Proposal #08: 1090-03-75, WISC 2025414
IH 43 - Airport Freeway
Hale I/C
IH 43
Milwaukee County

1100-05-73, WISC 2025415
IH 41 Airport Freeway
84th Street to N Lincoln Ave
IH 41
Milwaukee County

This is Addendum No. 03, which provides for the following:

**ADDENDUM NO. 03**  
**1090-03-75 & 1100-05-73**  
**April 3, 2025**

Addendum No. 01  
ID 1100-05-73  
Revised Sheet 33  
April 3, 2025

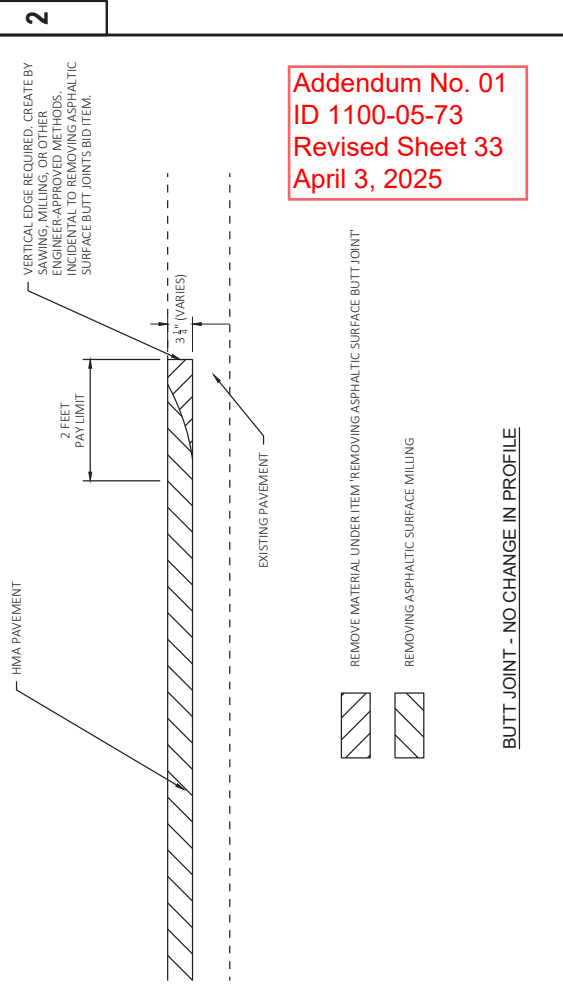
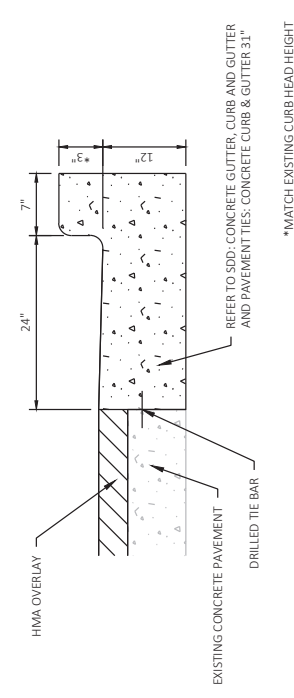
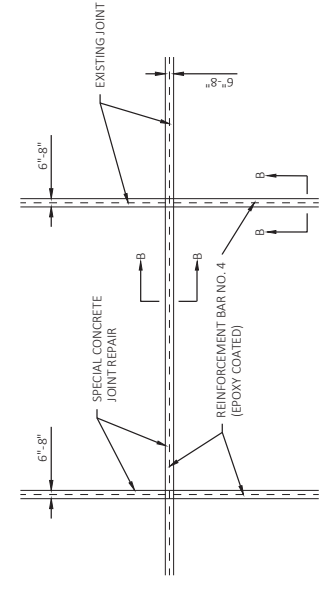
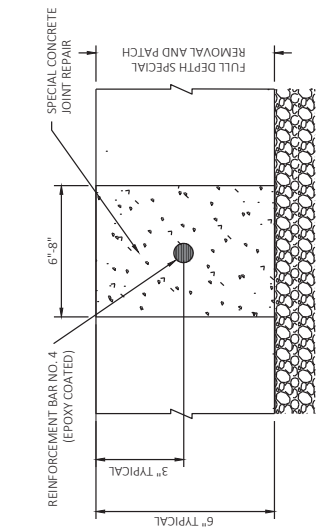
Table with 2 columns: Plan Sheet, Plan Sheet Title (brief description of changes to sheet). Rows: 33, Construction Details - Added a detail for the special concrete joint repair; 53-54, Removal Plan - Revised 'Removing Concrete Pavement' to 'Concrete Pavement Replacement SHES'; 478, Miscellaneous Quantities - Revised 'Removing Concrete Pavement' quantity
